**RE: Cutler Right-of-Way Dedication
Grading and Drainage Plan
Engineer's Stamp Date: 10/15/21
Hydrology File: H17D036**

Based upon the information provided in your submittal received 10/25/2021, the Grading and Drainage Plan is **not** approved for Work Order and for action by the DRB on Preliminary Plat. The following comments need to be addressed for approval of the above referenced project:

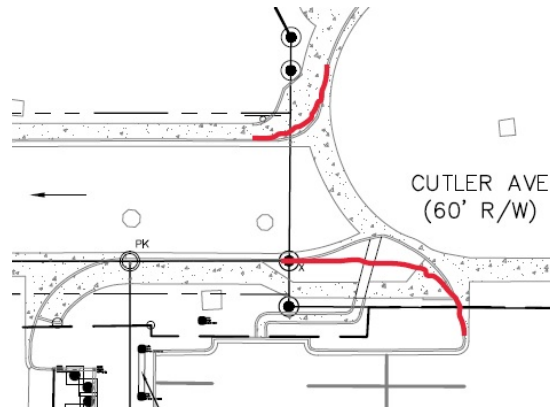
2. **Repeat comment** - Please verify the pipe size, material of the existing storm sewer. Also, please provide the rim elevation of the manholes, pipe inverts, inlet top of curb elevations.
3. **Repeat comment** - Also, please include any changes that will be done for the Work Order on the Grading Plan. For example, at the cul-de-sac the road will be flattened and straightened. (please see image below)

1. The revised Grading plan is being submitted for this portion of Cutler Avenue NE.
2. The existing storm drain pipe is RCP and several additional elevations have been added.
3. The proposed public storm drain alignment has been added. The cul-de-sac is located east of the project limits and is outside the scope of this work.
4. The proposed storm drain shown on the plan will be maintained by the City.
5. The existing drives will remain and accessible ramps will be added for crossings.
6. The existing road grades and cross-slopes will remain as is.
7. A public drainage easement will be required across the Green Jeans site as noted.
8. An area has been added showing the existing NMDOT inlet and discharge line running north to the channel.

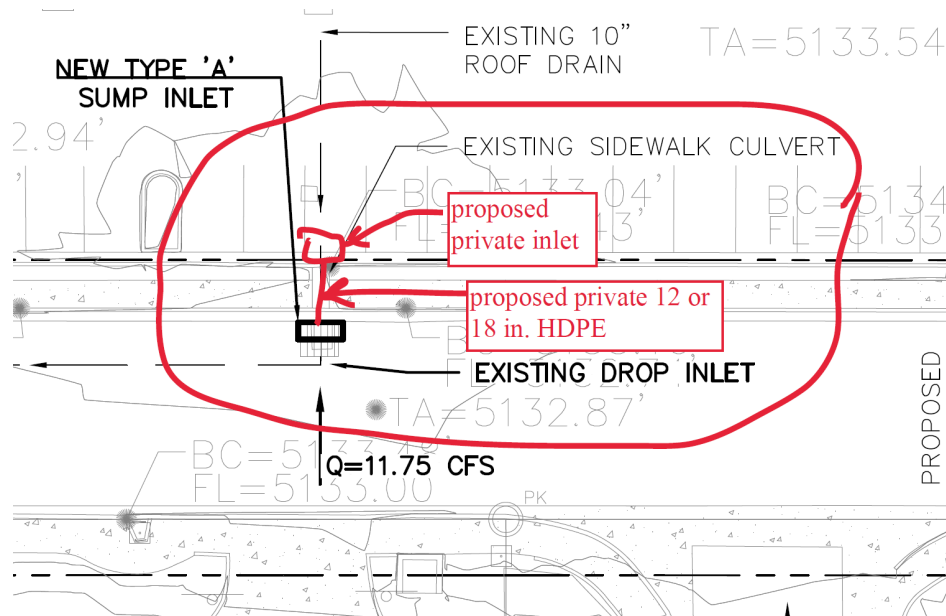
4. The drainage calculations needed for this should only be for the proposed Cutler Rd R.O.W. (this is the acres). All adjacent commercial tracts are considered off-site flows. This entire watershed should be shown with the off-site drainage areas shown as well. This should be the drainage map for the calculations.
5. Please provide the proposed cross-section of the proposed Cutler Rd. R.O.W.
6. Please provide the street calculations for the above proposed Cutler Rd. R.O.W.
7. Please provide the storm pipe calculations.
8. In order to install the new Type A inlet in Cutler Rd, the existing sidewalk culverts will have to be removed, a new proposed private inlet and a new proposed HDPE pipe to the back of the new Type A inlet.

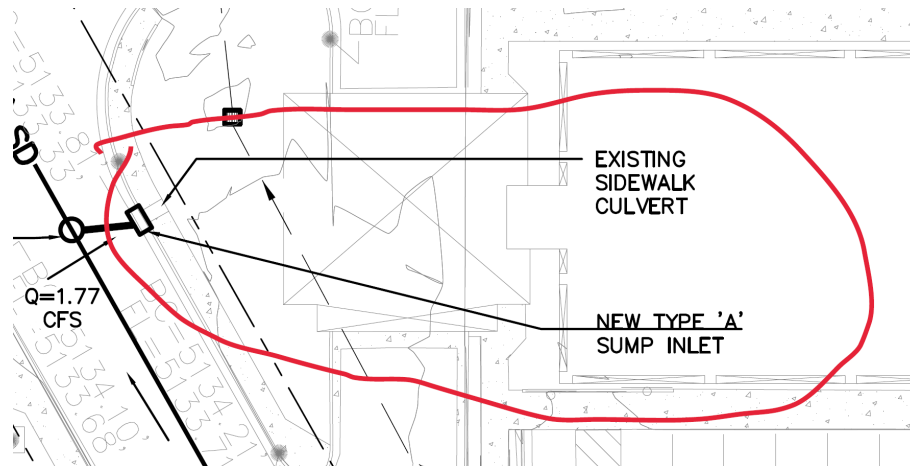
9. Same as above, in order to install the new Type A inlet in Cutler Rd, the existing sidewalk culverts will have to be removed.

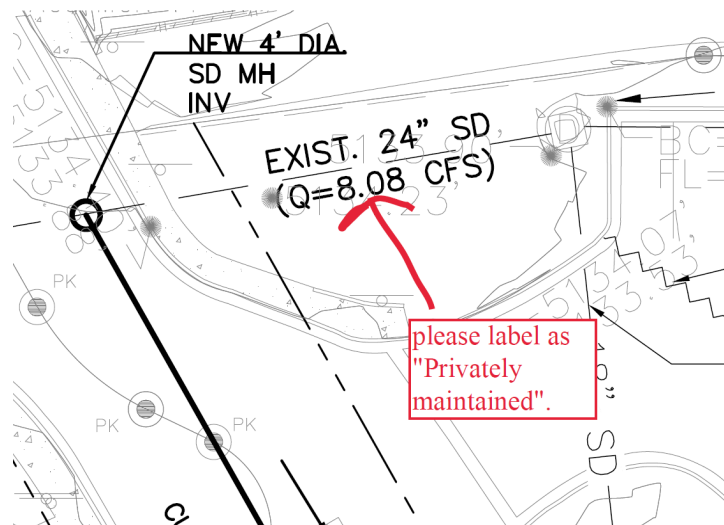
10. Please label all private storm pipes as "Privately maintained".

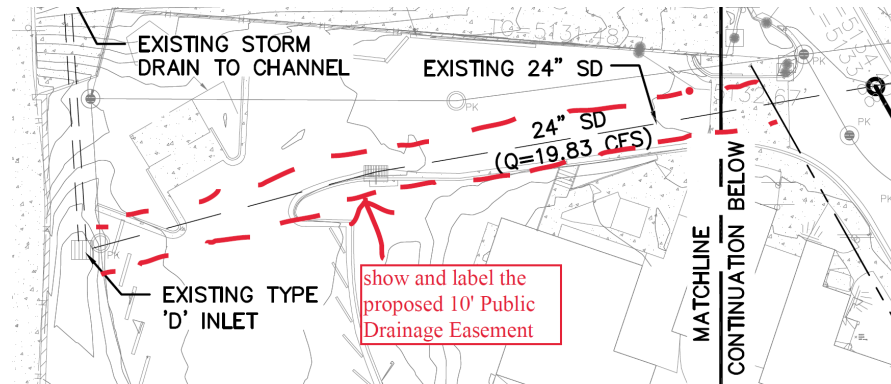
11. Please show and label the proposed 10' Public Drainage Easement.
